## **Addendum No. 2**

### **REBID TRUCKEE CANYON WATER SYSTEM EXPANSION**

**PWP Bid No. WA-2016-158**  
**June 8, 2016**

TYPICAL AIR VALVE ASSEMBLY

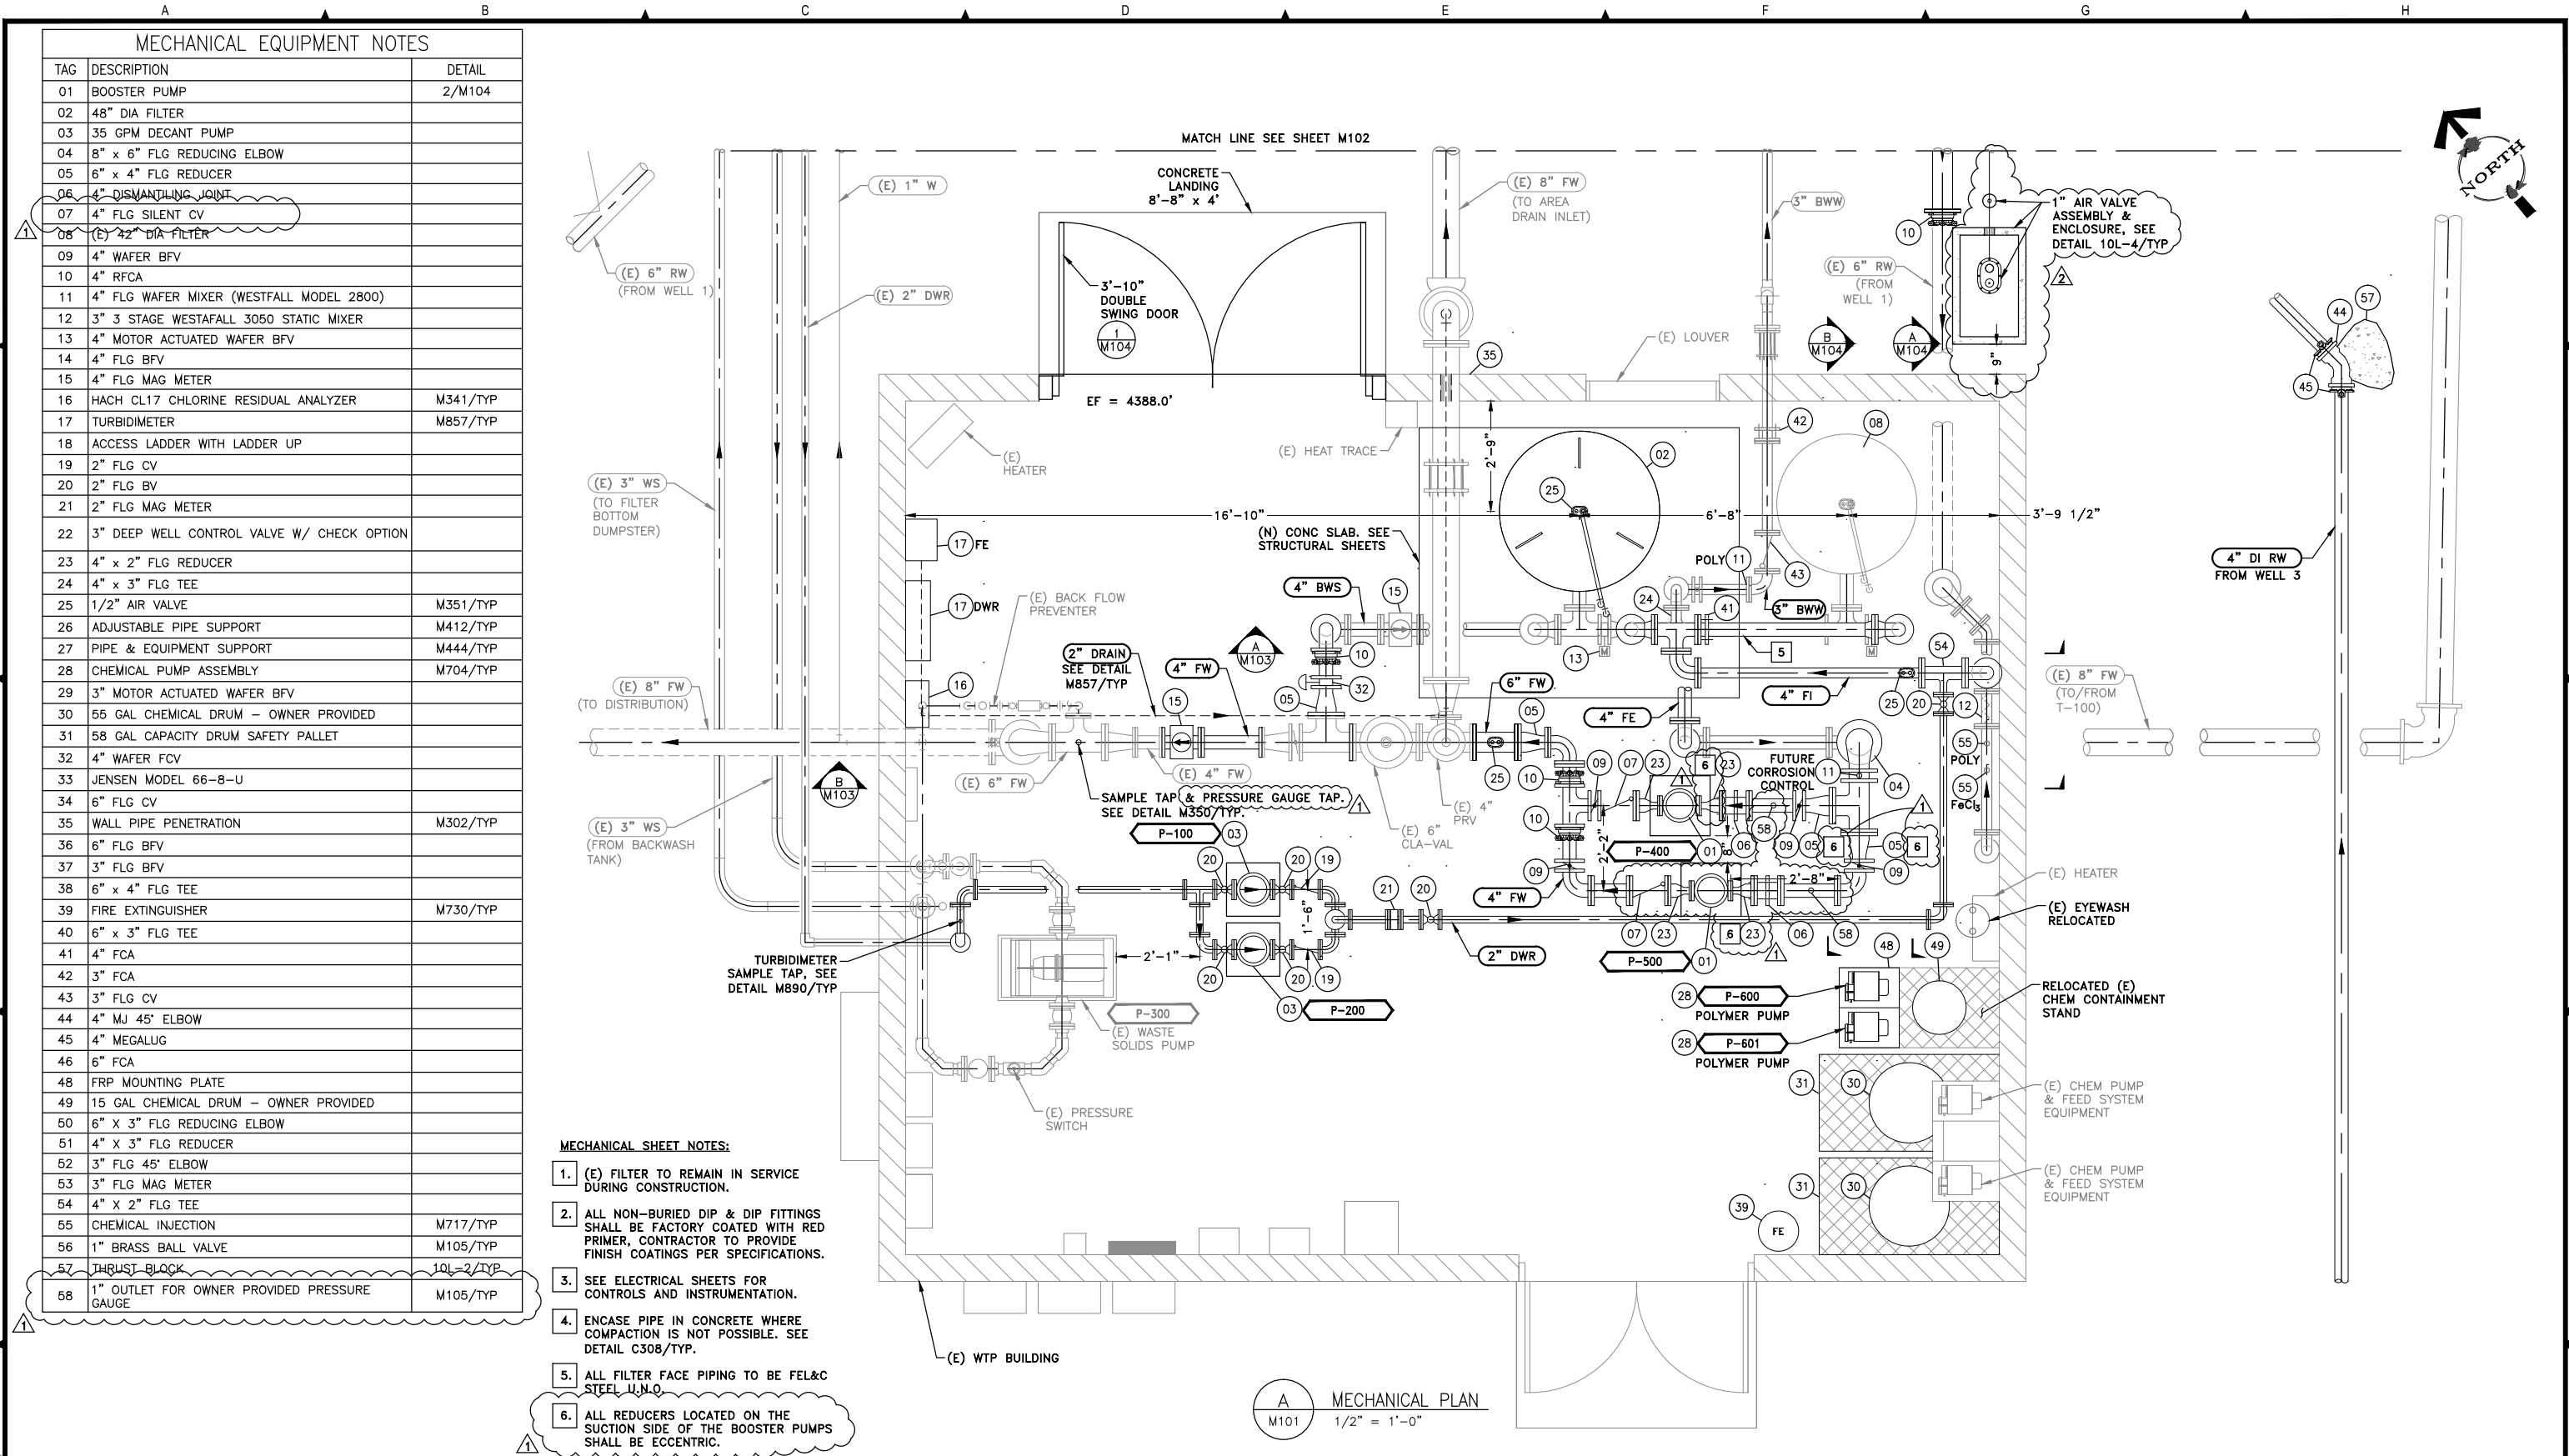
Section	Page(s)	Description of amendment
M351/TYP	21	The 1 inch air valve assembly in Detail M351/TYP was replaced with a typical air valve assembly. Please see attached.

**M101**

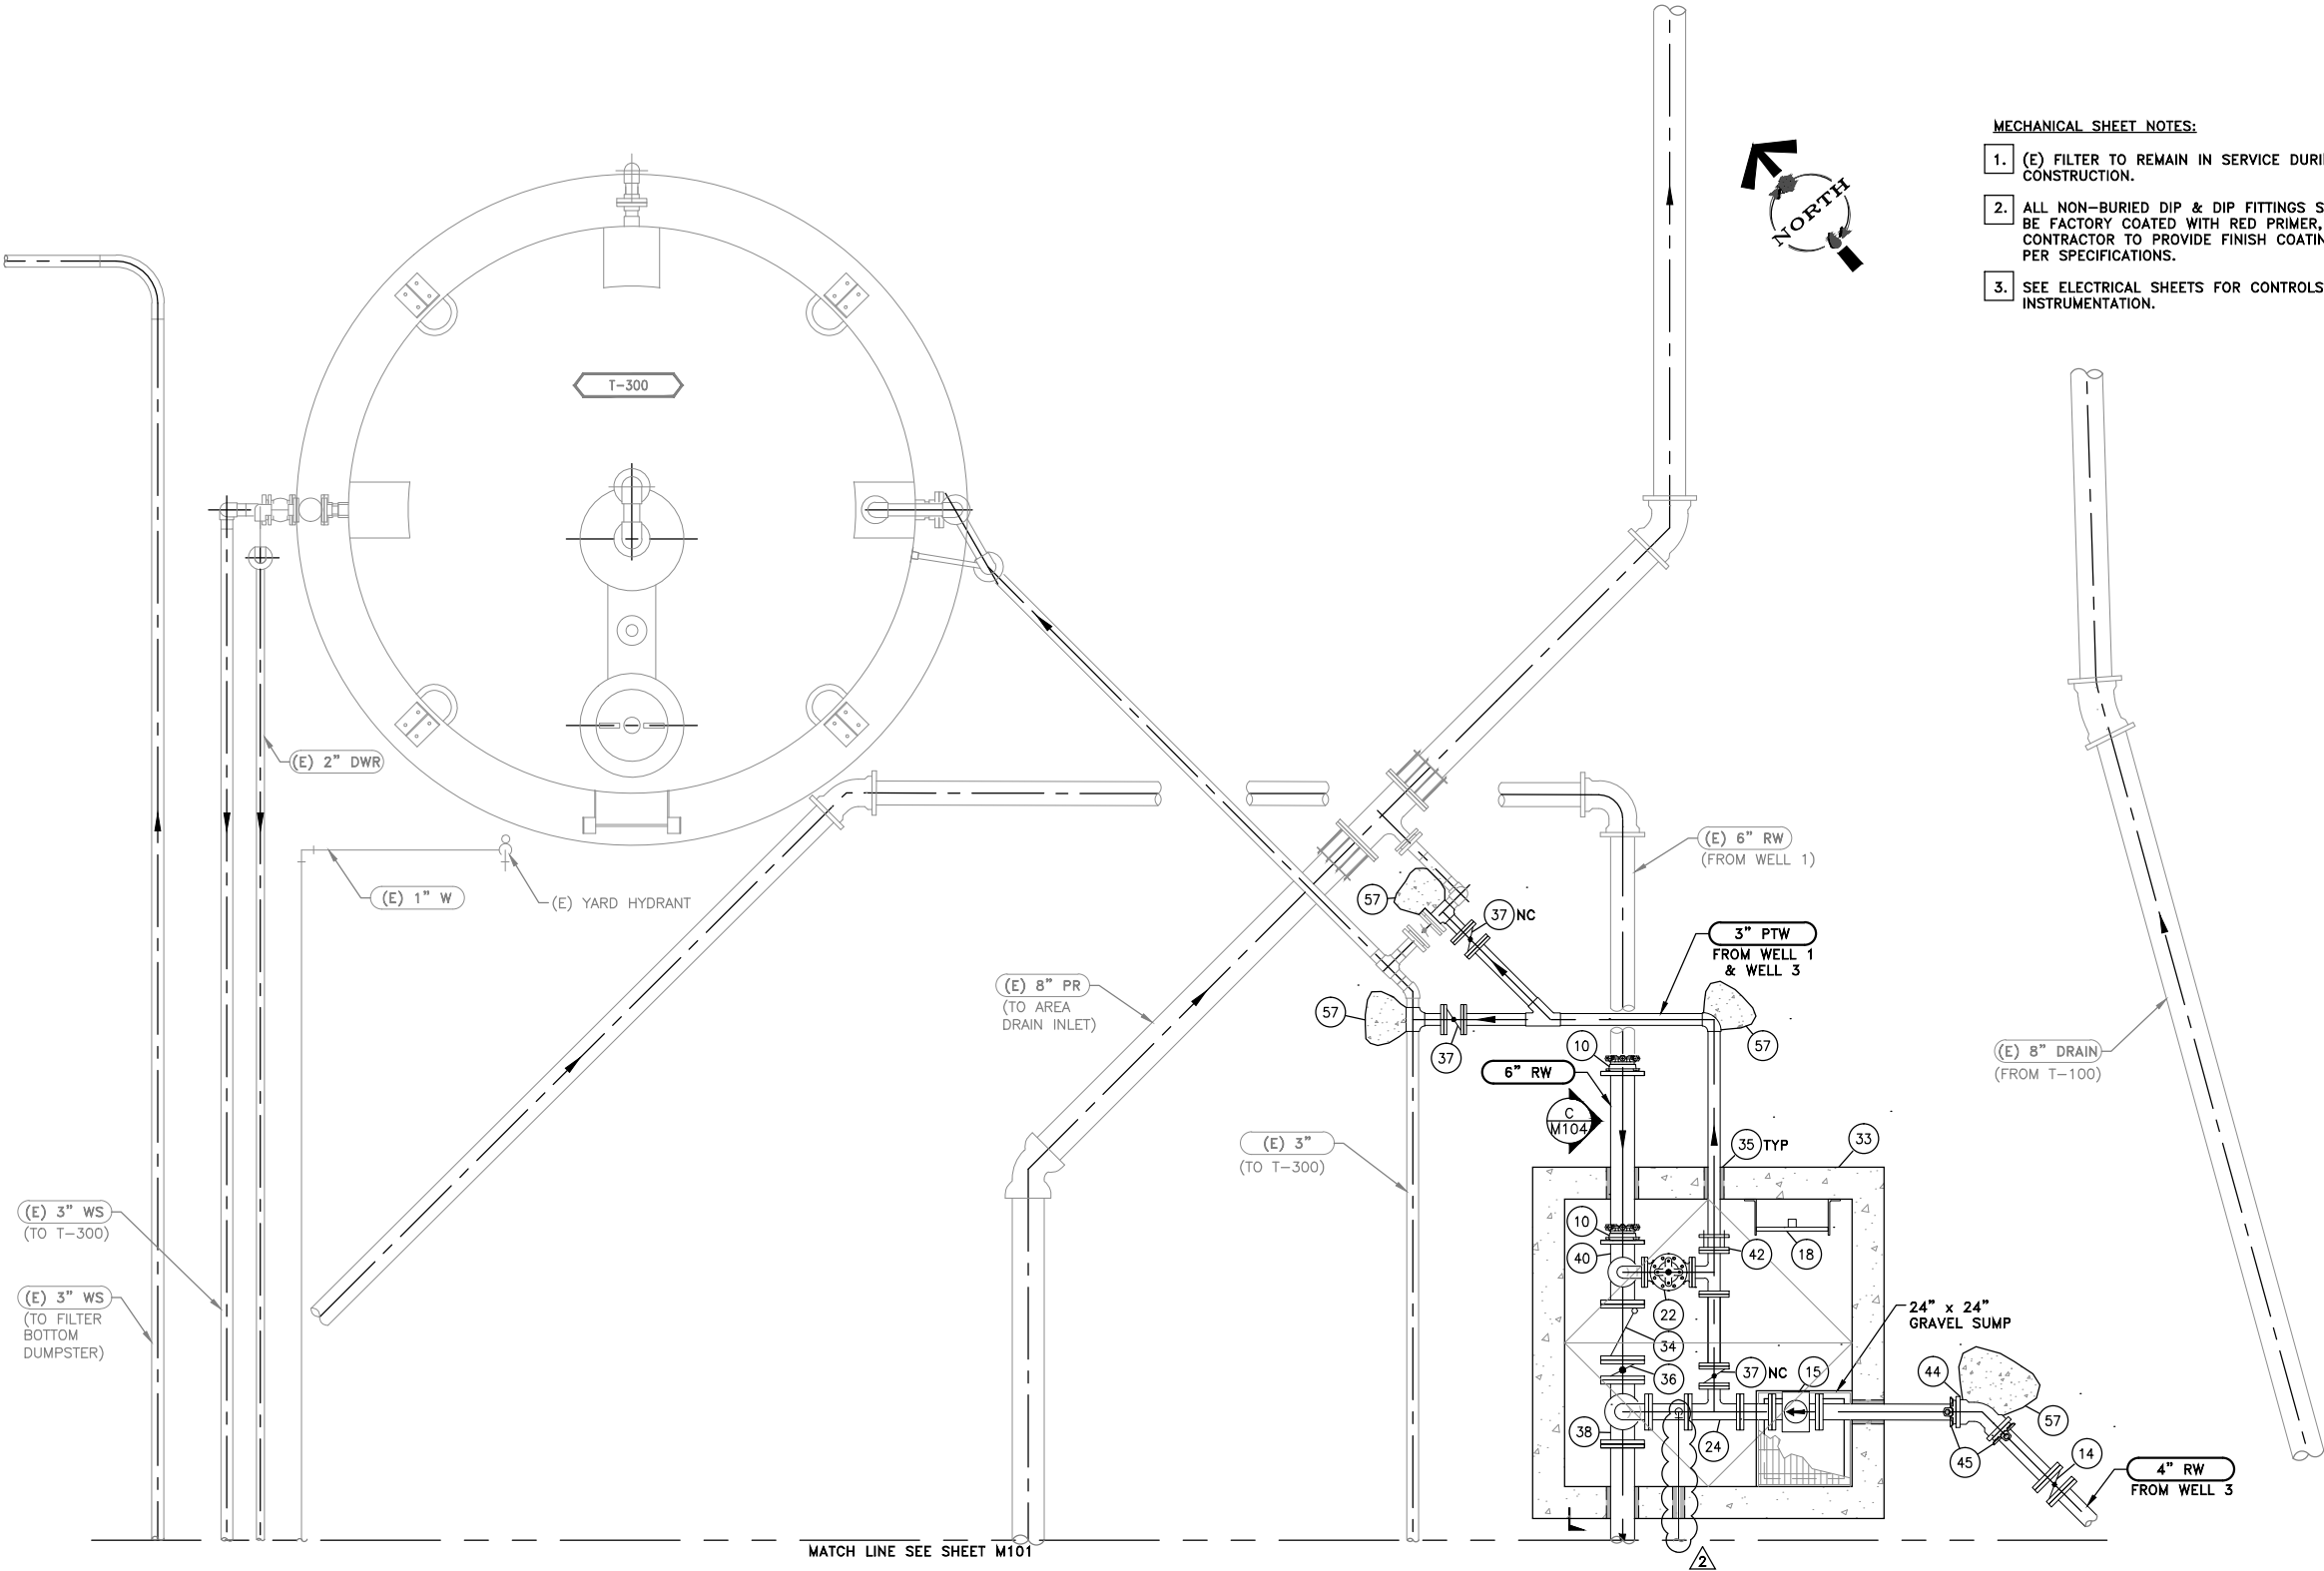
Sheet Number	Page(s)	Description of amendment
M101	27	Please see attached M101 for changes to the Well 3 tie in ARV.
M102	28	Please see attached M102 for changes to the Well 3 tie in ARV.
S100	32	Please see attached S100 for changes to the basis of design.
S102	34	Please see attached S102 for changes to detail 3/S102.
